## Meeting Agenda - Final

Staff Report

## File #: 25-0170

Consideration of a Conditional Use Permit in the General Commercial (C2) zone at 10636 W. Blue Mound Road to allow site modifications and convenience store expansion to an existing gas station, Emad Nadi, ETN Engineering, applicant

1 Site Plan 1" = 10'-0"

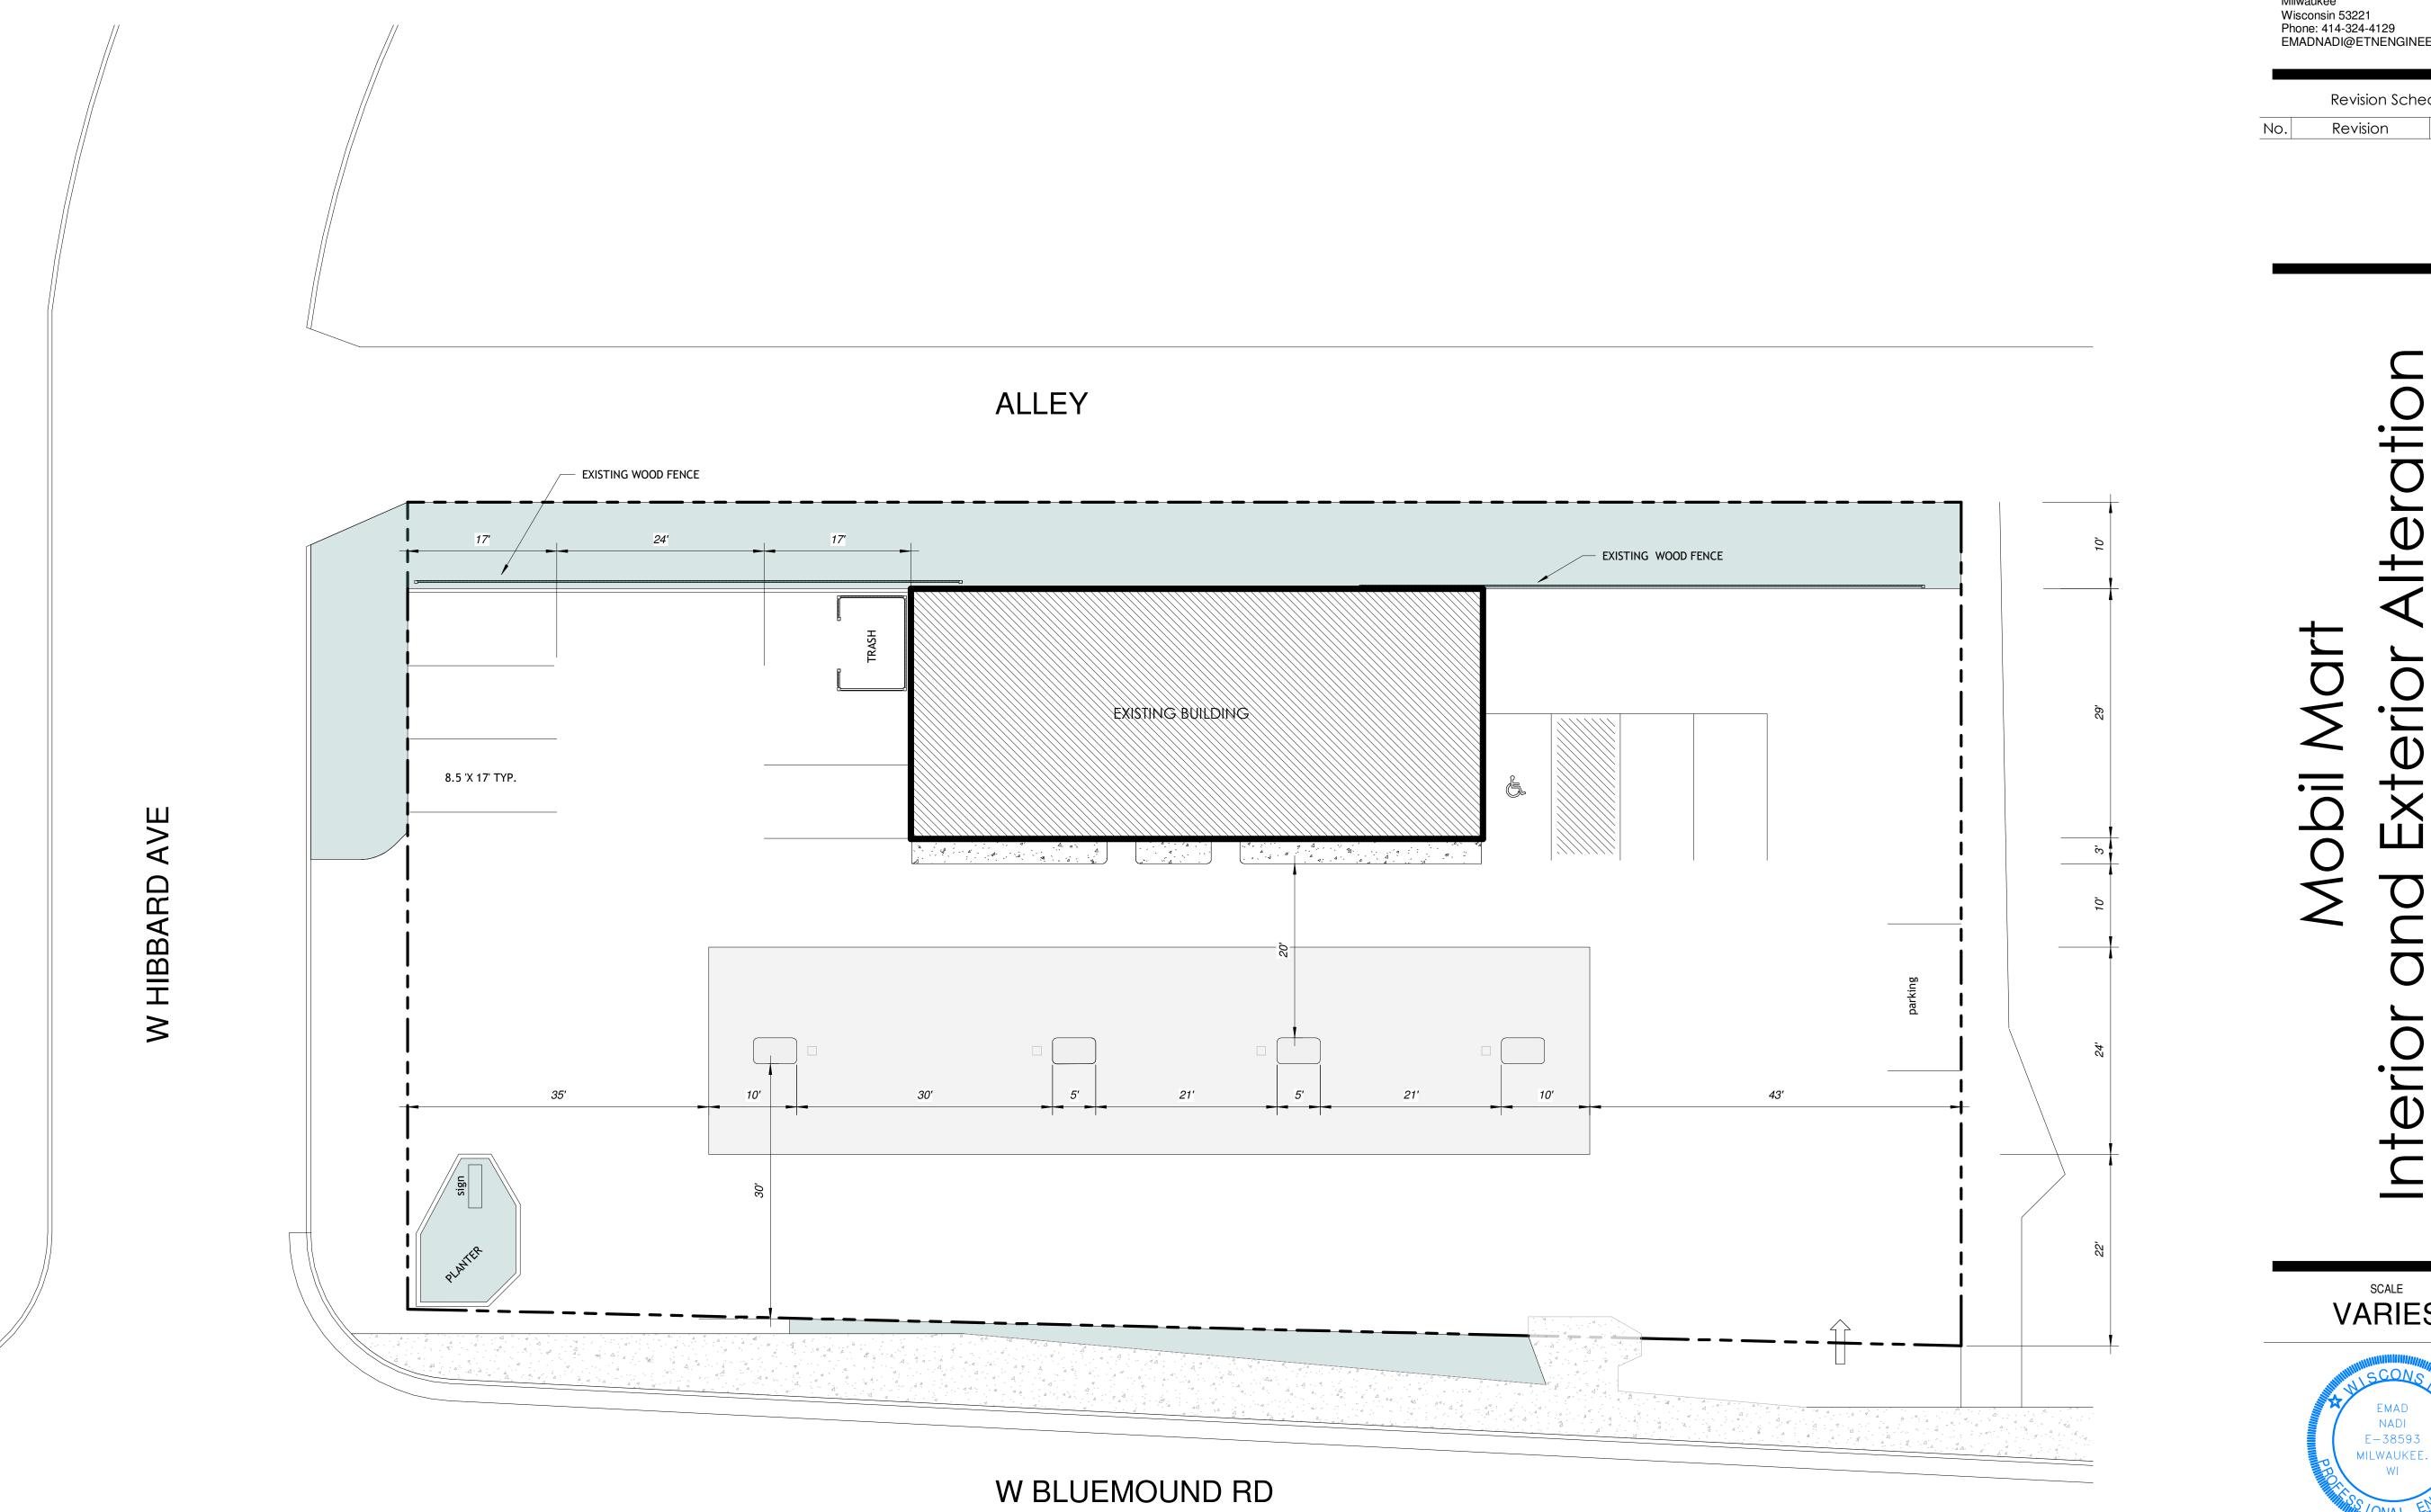
Four (4) parking spaces for every 1,000 square feet of convenience store space must be provided. Based on the convenience store square footage, seven (7) parking spaces are required and the plans show seven (7) parking spaces.

The proposed canopy location may impact the use of the existing onsite parking stalls. The site plan must include the location of any existing and proposed parking stalls. Include a site data table that quantifies the square footage of the existing and expanded convenience store. City Zoning Code requires that 4 parking spots must be provided per 1000 square feet of convenience store space. If the parking stall locations change from the existing locations, a site plan/parking lot permit will be required through the Engineering Department.
